7th October 2020 Reference: 190226.23FC

Port Macquarie-Hastings Council
Attention: Patrick Galbraith-Robertson

# PARKING DEMAND SUMMARY FOR THE LEISURE AND ENTERTAINMENT PRECINCT AT CNR WARLTERS STREET AND PARK STREET, PORT MACQUARIE

FIGURE 4: EXPECTED SATURDAY CINEMA PARKING DEMAND

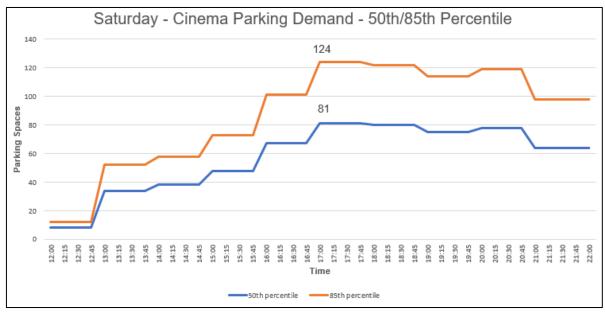
Council has requested further information on how the cinema parking demand varies throughout the year and how it will in turn affect the expected overflow parking quantities. MTE's *Traffic and Parking Impact Assessment* (reference 190226.10FA) used the cinema's 85<sup>th</sup> percentile parking demand, which is standard engineering practice for design. However, to understand the typical parking environment, one would need to use the 50<sup>th</sup> percentile (or average) parking demand. The 85<sup>th</sup> and 50<sup>th</sup> percentile parking demands for the proposed cinema are provided in **Figure 3** and **Figure 4**.

As shown, there is a large difference in car parking demand between the 50<sup>th</sup> and 85<sup>th</sup> percentile parking demands. Therefore, there is expected to be a significantly lower parking overflow in the average 50<sup>th</sup> percentile condition, compared to the 85<sup>th</sup> percentile demand which was assessed in MTE's *Traffic and Parking Impact Assessment* (ref 190226.10FA).
